**TRUCK UTILITY MEDIUM (TUM) HIGH SPECIFICATION
(HS) HARD TOP (HT) W/ VPK
SNATCH-2A, SNATCH-2B AND SNATCH-VIXEN PLUS**

MODIFICATION INSTRUCTION No. 29

SUBJECT: Front upper seatbelt anchorage points

Fig 1 Dipstick support kit

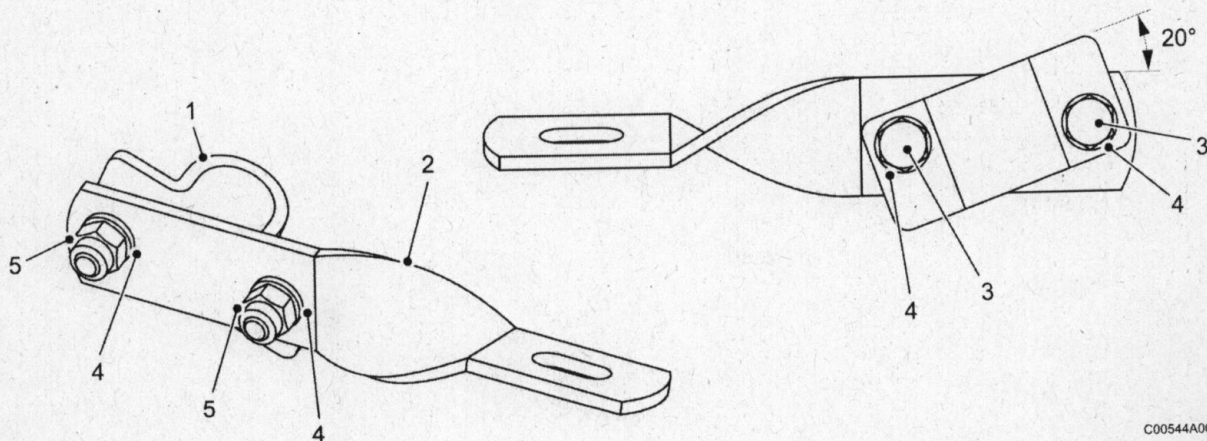
8.1.1 The following items are to be demanded quoting this instruction as authority for demand. Fig 1 shows the items associated with the modification kit.

Fig 2 Location of the dipstick within the engine

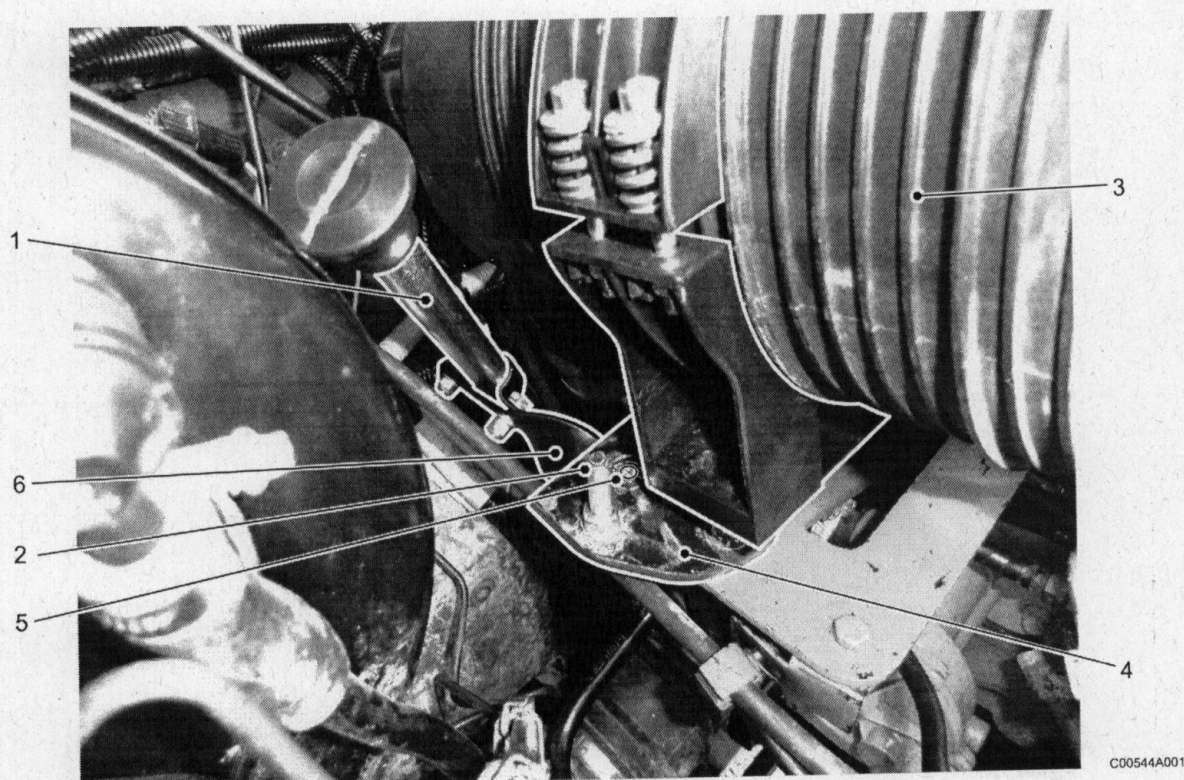
- 10.1 Remove two nuts and washers from the captive screws (Fig 2.2) holding air cleaner to the support plate.
- 10.2 Remove the air cleaner (Fig 2.3) to provide access to the dipstick support bracket fixing point.
- 10.3 Remove the Nyloc nut and washer from the underside of the air cleaner support plate (Fig 2.4), attached to the countersunk screw (Fig 2.5).

- 11.1 Fit the single slotted end of the dipstick support bracket (Fig 2.6) to the underside of the air cleaner support plate (Fig 2.4) ensuring it is the correct way up. Loosely hold in place with the Nyloc nut, washer and countersunk screw.
- 11.2 Locate dipstick clamp (Fig 1.1) around the dipstick tube (Fig 2.1) and align the holes.
- 11.3 Place the Hex HD set screws (Fig 1.3) and flat washers (Fig 1.4) through the dipstick clamp side and secure with the Nyloc nuts (Fig 1.5) and flat washers (Fig 1.4) from the bracket side.
- 11.4 Ensure all nuts and bolts are tightened securely.

11.5 Refit the air cleaner (Fig 2.3) onto the air cleaner support plate (Fig 2.4).

11.6 Fit and tighten nut and washer onto the captive screws (Fig 2.2).

Fig 1 Upper seatbelt buckle removal

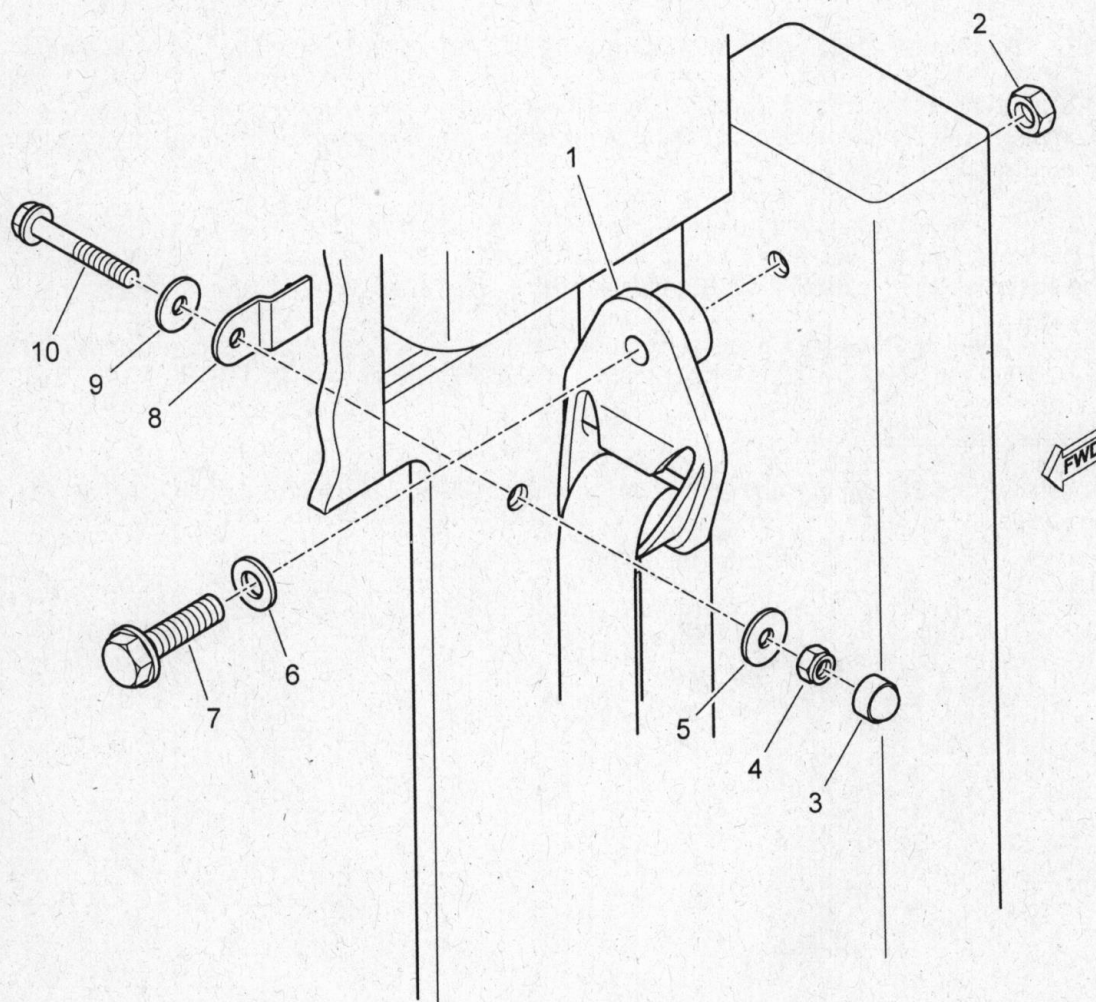
10 To remove the existing upper seatbelt buckle (Fig 1(1)) proceed as follows.

10.1 Remove and discard the bolt (7) complete with plain washer (6) and nut (2). Ensure that the upper seatbelt buckle is supported during the bolt removal, as the seatbelt is under spring tension.

10.3 Remove the barracuda buckle strap(s) attached to the barracuda bracket(s)(8) to allow space for removing fixings.

10.4 Remove screw (10) complete with plain washer (9), barracuda bracket, penny washer (5), nyloc nut (4) and end cap (3), which fix to the S-GLASS. Discard the barracuda bracket, retain all other fixings and end cap.

Fig 2 Mounting plate removal

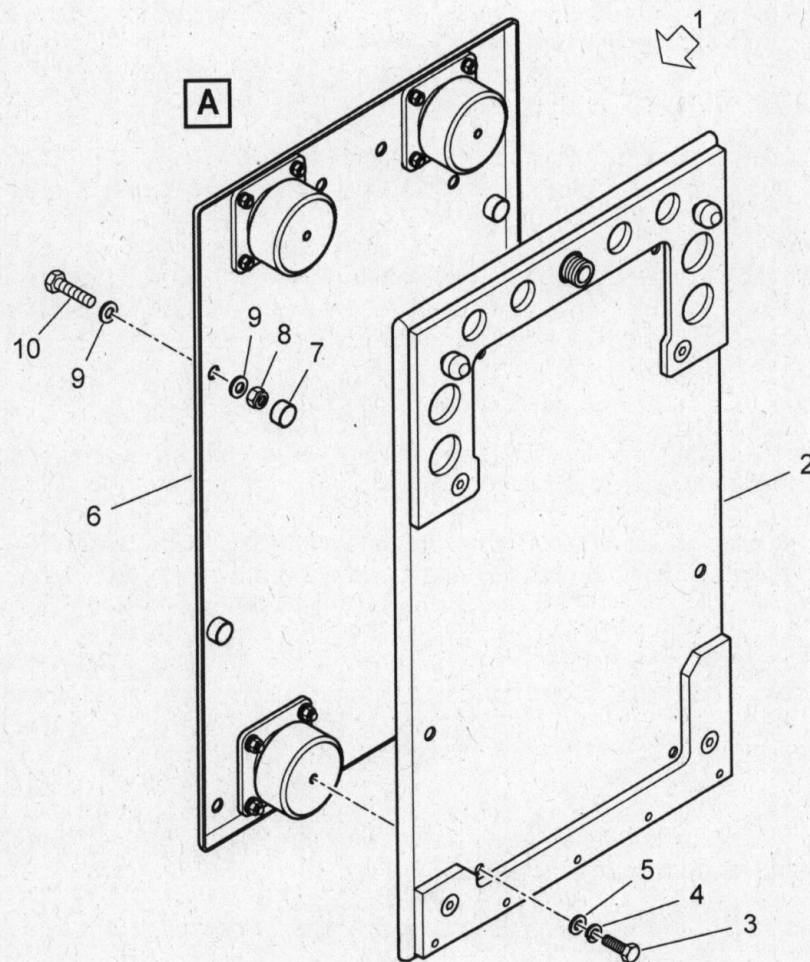
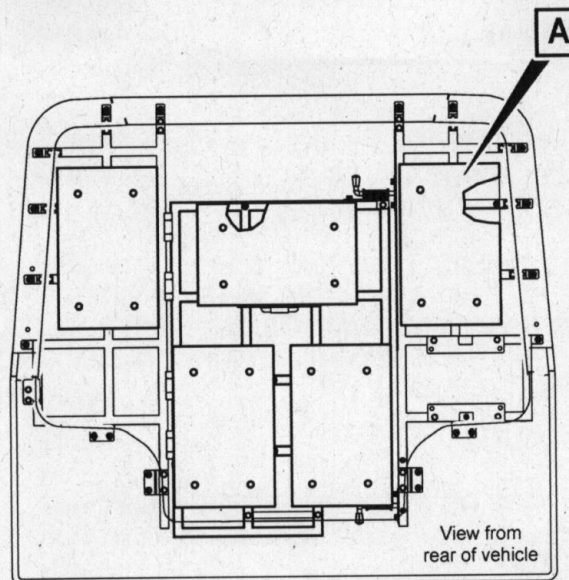
12 To gain access to the RH front upper seatbelt buckle rear fixings, it is required to remove the RH upper mounting plate (Fig 2(6)) to access the rear nut securing the front upper seatbelt buckle. To remove the mounting plate proceed as follows:

12.2 Remove the impact plate (2) from the mounting plate by removing the four screws (3) complete with spring washers (4) and plain washers (5). Discard the spring washers and retain all other fixings.

12.3 Remove the mounting plate by removing and retaining the four screws (10) complete with plain washers (9), nyloc nut (8) and protective caps (7). Once removed, access to the rear nut will be possible, taking care of the loose cabling in this area. Discard nyloc nut and retain other fixings.

Fig 3 Bracket, seatbelt anchor RH installation

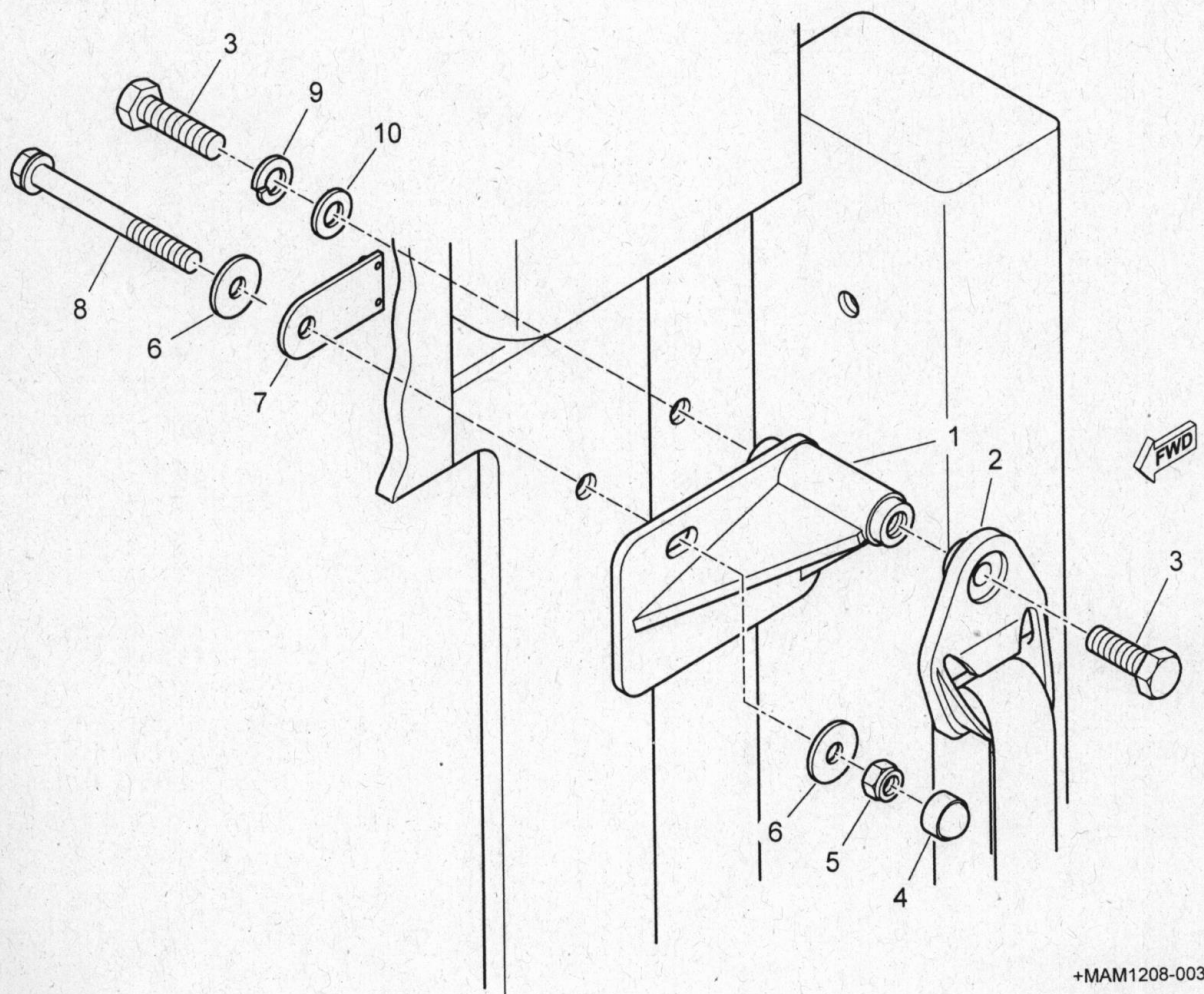
16 An additional mounting point for the bracket, seatbelt anchor RH (Item 14)(Fig 3(1)) is required on the S-GLASS. To install the additional fixing point for the bracket, seatbelt anchor RH, proceed as follows:

16.1 Loosely secure the bracket, seatbelt anchor RH using retained fixings from Para 10.4. Ensuring the bracket, seatbelt anchor RH is at a right angle and the additional mounting point is parallel to the mounting used to loosely secure the bracket, seatbelt anchor RH.

16.2 Mark the position for the additional fixing on the S-GLASS, using Fig 3 for reference. Remove the bracket, seatbelt anchor RH and discard the previously retained fixings. A suitable G-clamp (locally sourced) may aid this process by securing the bracket, seatbelt anchor RH.

17.1 Secure the bracket, seatbelt anchor RH to the S-GLASS using screw (Item 12)(3) with Arboseal (Item 21) applied, complete with spring washer (Item 19)(9) and plain washer (Item 17)(10). Torque tighten to 94 – 107 Nm.

17.2 Secure screw (Item 13)(8) complete with plain washers (Item 18)(6), bracket, barracuda (Item 15)(7), nyloc nut (Item 16)(5) and the retained end cap (4). Torque tighten to 42 Nm and refit barracuda strap(s) to bracket, barracuda.

17.3 Secure the upper seatbelt buckle to the upper seatbelt anchor bracket using screw (Item 12)(3). Torque tighten to 94 – 107 Nm.
